DC/22/93211 - Discharge of conditions 7 (Levels & Retaining Walls), 8 (Access roads/lighting), 9 (Foul and Surface drainage) and 16 (Central garden spaces for Blocks B, C, D & E) for Boorley Park Local Centre

22.6.23 - Landscape verbal consultation response re: conditions 7 and 16 following queries from agent.

Landscape Proposals Sheet 4

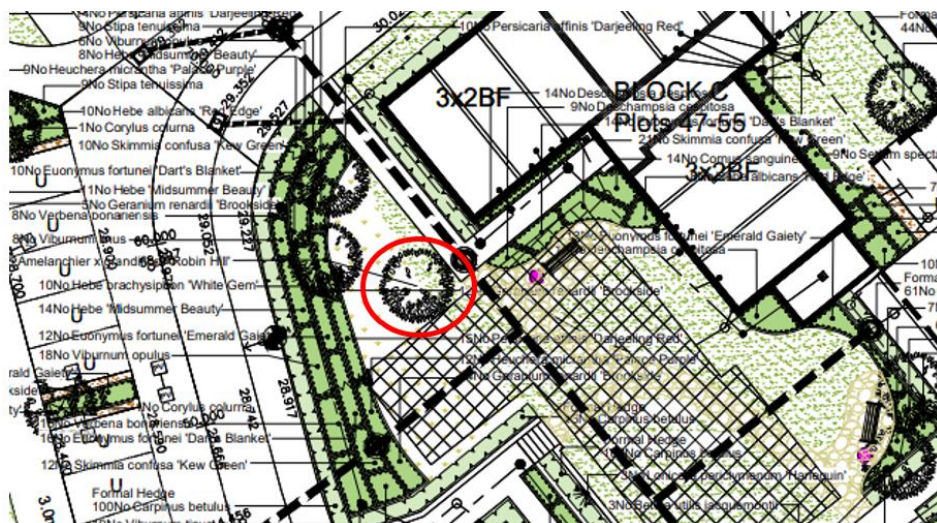
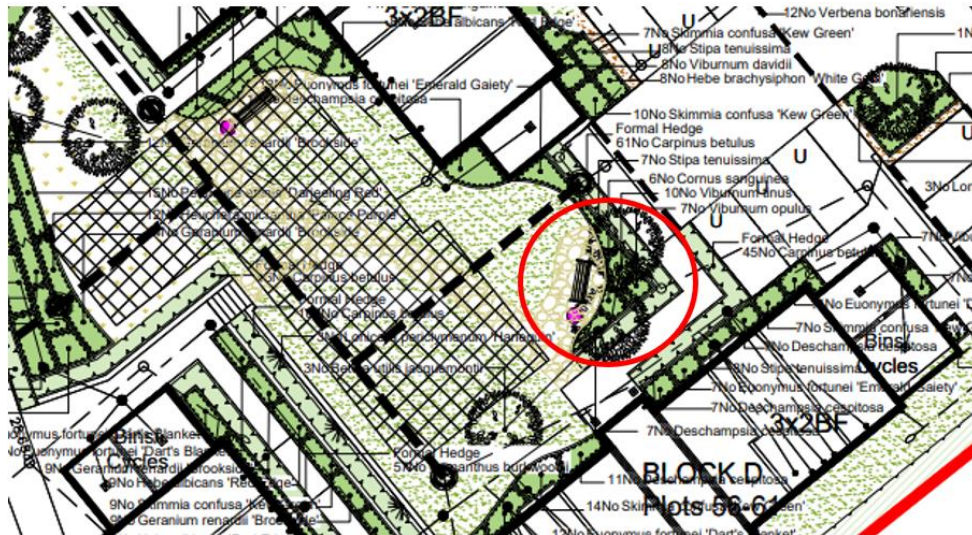
1. Please add a revision notes and letters to the plan. There are none at present.
2. Thanks for changing the birch to Jacquemontii cultivar. Please add connection lines to clarify that the label applies to all 3 trees in this group. Also please tweak the viburnum label so it doesn't appear to end at the trunk position of one of these trees.
3. To ensure there is no conflict with the underground water storage tank move the southern-most tree adjacent to Block C, 5m to the west and confirm the depth of soil above the water tank and whether the top of the water tank is permeable or solid.

4. The seating in the eastern corner of the garden would not currently provide shade in the middle third of the day, as required by the condition, so move seat towards bed by 0.5m and move trees west by 0.5m.

5. 1m-1.2m high railings need to be provided on top of the retaining wall to the east of Block E, rather than the proposed fence, to ensure a more satisfactory appearance and reduce the sense of enclosure for residents in Block E. This will require new retaining wall details and a change to the hard landscape drawings to be submitted.
